Advanced LIGO PSL

presentation of the PSL team at the
preliminary design review

LIGO-G080539-00-Z

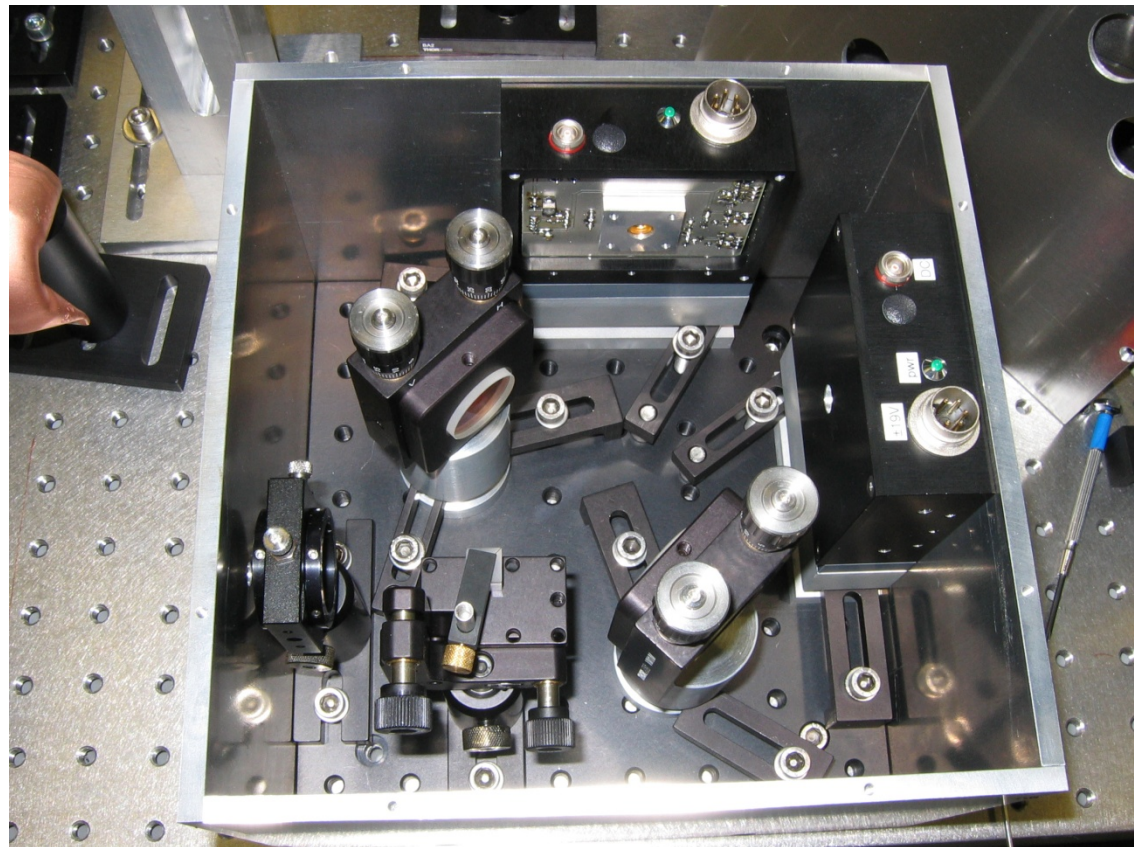
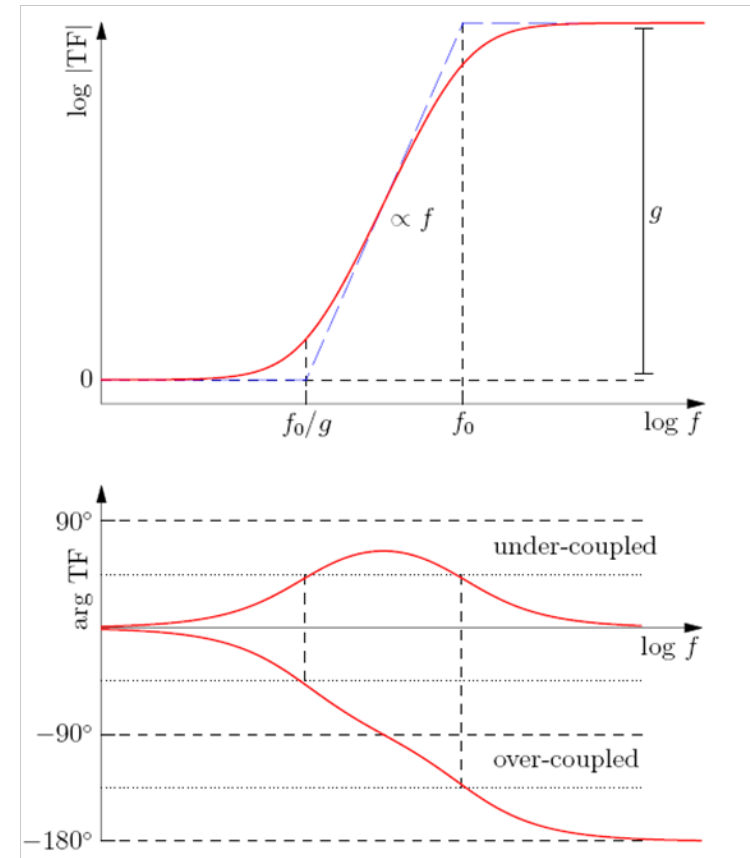
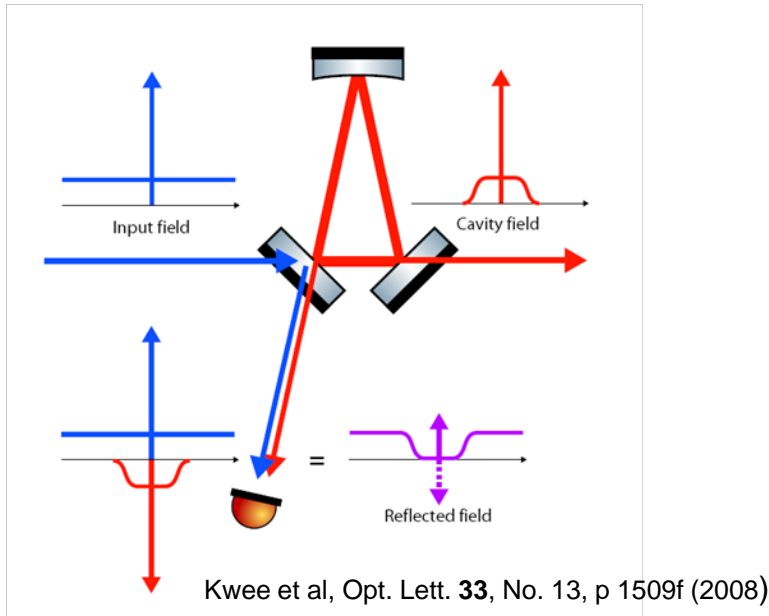
L:ISS outer loop sensing. Is this (in-vac) sensor planned to be one or two PDs? We suggest this be two PDs with a 50/50 splitter, so comparisons can be made.

- the plan is to use two diode for out-of-loop sensing

Notes: 180W, June 08 before PMC

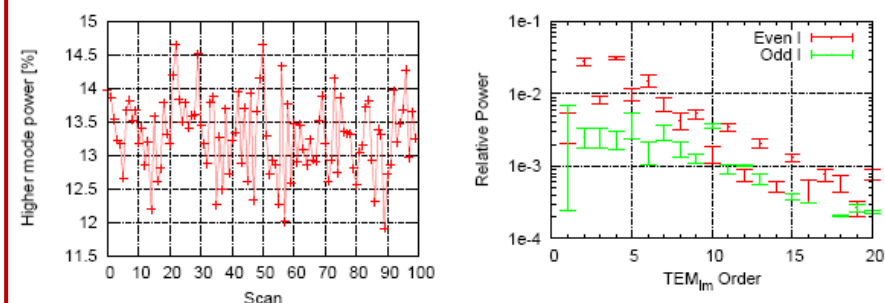
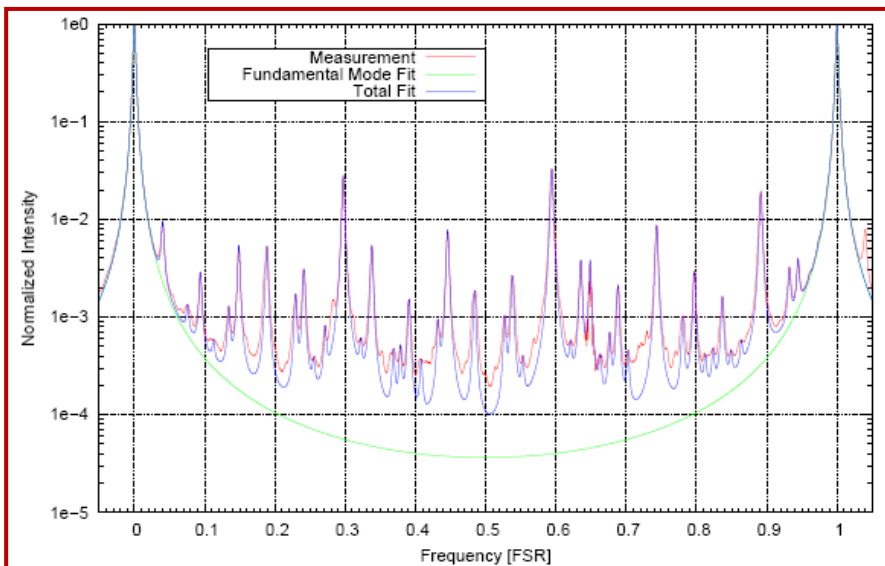
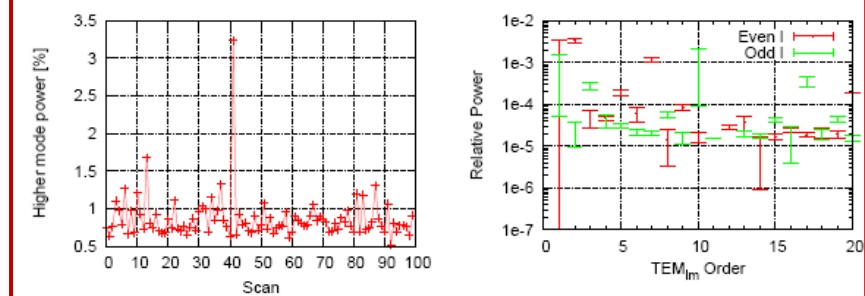
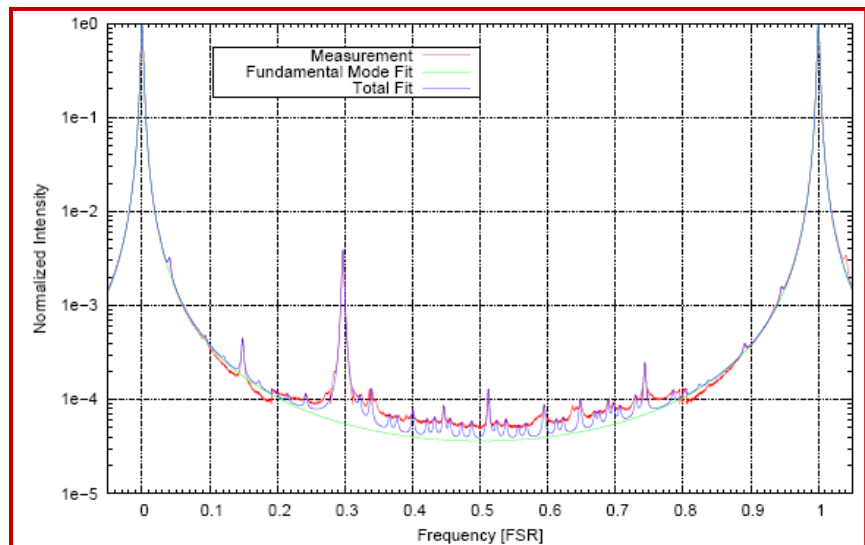
M: How do you plan on reducing the higher order mode content of the high power output beam (p15 of PDD)? How well do you think you can do?
